Subject: MHI's Response to US-APWR DCD RAI No. 122-795 Revision 0

Response to Request for Additional Information
No. 122-795 Revision 0

**US-APWR Design Certification
Mitsubishi Heavy Industries
Docket No. 52-021**

RAI NO.: 122-795
SRP SECTION: 06.02.01.05- MINIMUM CONTAINMENT PRESSURE ANALYSIS FOR EMERGENCY CORE COOLING SYSTEM PERFORMANCE CAPABILITY STUDIES
APPLICATION SECTION: SRP 6.2.1.5
DATE OF RAI ISSUE: 12/3/2008

Figure-1 Heat Absorption Rate from the Containment Atmosphere

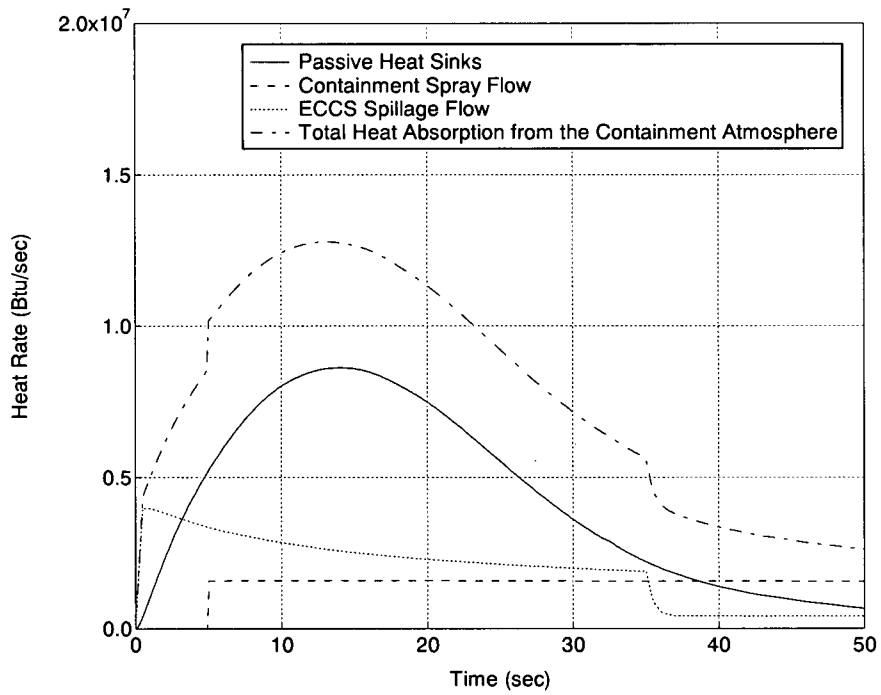
6.2.1.5: Figs. 6.2.1-80 and 6.2.1-81 show the peak temperature and pressure in the containment occur around 10 s, but the peak heat transfer coefficient in Fig. 6.2.1-83 occurs at 33 s. Table 6.2.1-28 shows an end of blow-down also at about 33 s. Please, explain/clarify the discrepancy on the timing of these peaks (10s vs 33s).

The peak pressure and temperature in the containment generally occur when the heat absorption from the containment atmosphere exceeds the energy release rate.

Figure-1 shows the total heat absorption rate from the containment atmosphere and the comprising parts, i.e. heat transfer and condensation to the passive heat sink surfaces, to the containment spray flow, and to the ECCS spillage flow. Additionally, there is some small heat absorption due to interfacial heat and mass transfer on the condensed RWSP that is negligible compared with the above. Figure-1 indicates that the total heat absorption rate is dominated by the heat transfer and condensation at the passive heat sink surfaces.
